Addendum 002

19-B0048

ECT 3rd – 9th Avenue South

October 30, 2018

SCALE: 1" = 20'
 DATE: 08/19/19
 DRAWING NO.: 000
 PROJECT NO.: 11008
CC-4
 P.F. 02

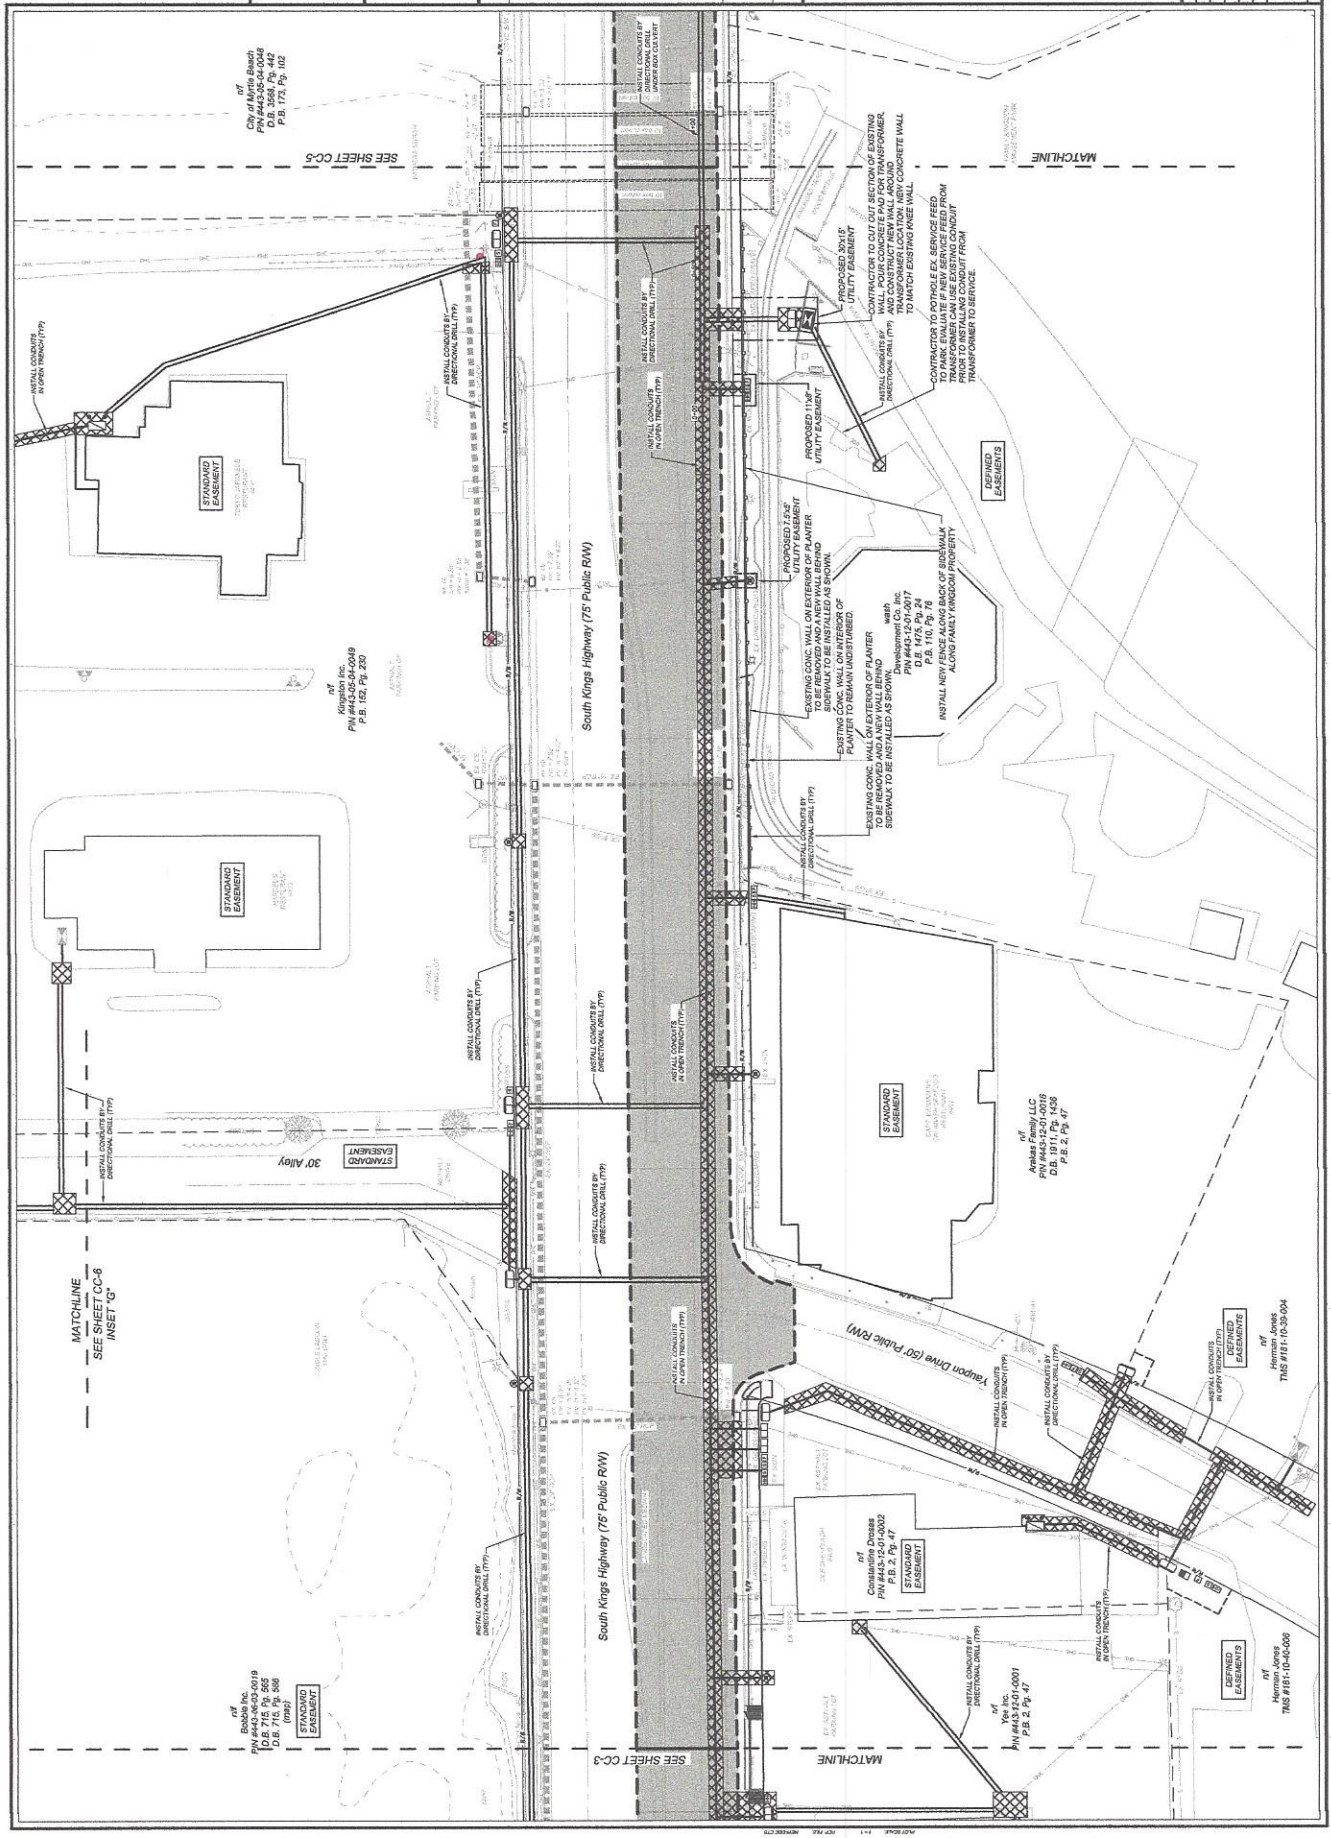
1. Sheets SC-4 & CC-4 have the Santee Cooper enclosure on the Ole Shillelagh property rotated 180 degrees.
2. Sheets SC-5 & CC-5 have added two Santee Cooper pull boxes (enclosures) on the Wings Beachwear Store property to facilitate pulling their primary power wires through this area.
3. Sheet CCD-2 has the conduit installation detail changed to show gaps between the conduits installed in the trench to assist backfill compaction around the conduit bank.
